Re: Finance Docket No. 36284 - Seven County Infrastructure Coalition - Uinta Basin
Railway Project - Response to Information Request No. 4

Seven County Infrastructure Coalition's Response to the
STB Office of Environmental Analysis October 30, 2019
Request for Information No. 4

Figure 1: Map of Avintaquin Canyon Route
(Not-to-Scale)

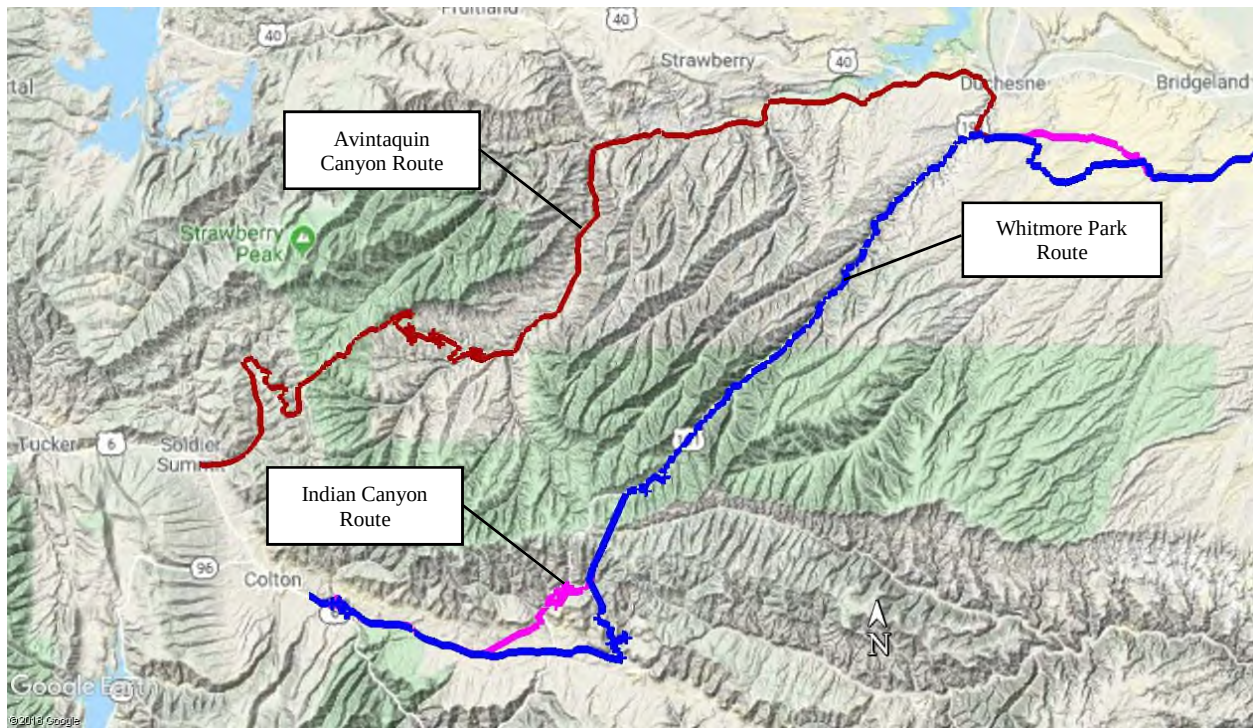
c. Please provide any additional information (such as ruling grade, curve radius, cut-and-fill volumes, or tunnel design details) that the Coalition considered in evaluating the feasibility of the Avintaquin Canyon Route.

Coalition Response: The Avintaquin Canyon Route was based on a route surveyed, but never constructed, by the D&RGW Railway in 1925. The D&RGW Railway route was used as a starting point and modified as appropriate to achieve proposed design standards for the Uinta Basin Railway. A map of the Avintaquin Canyon Route, identified by the red route line, is provided in Figure 1. In order to achieve the maximum gradient established for the Uinta Basin Railway, the route follows a circuitous path that lies on angle-of-repose mountain slopes. This circuitous path is necessary both to avoid areas of great relief and tunneling, as well as to meet maximum grade requirements.

The Avintaquin Canyon Route was thoroughly evaluated and withdrawn from further consideration in the spring of 2019. The decision to remove this route from further consideration was based primarily on the considerable engineering challenges associated with the extremely rugged topography along the Avintaquin Canyon Route.
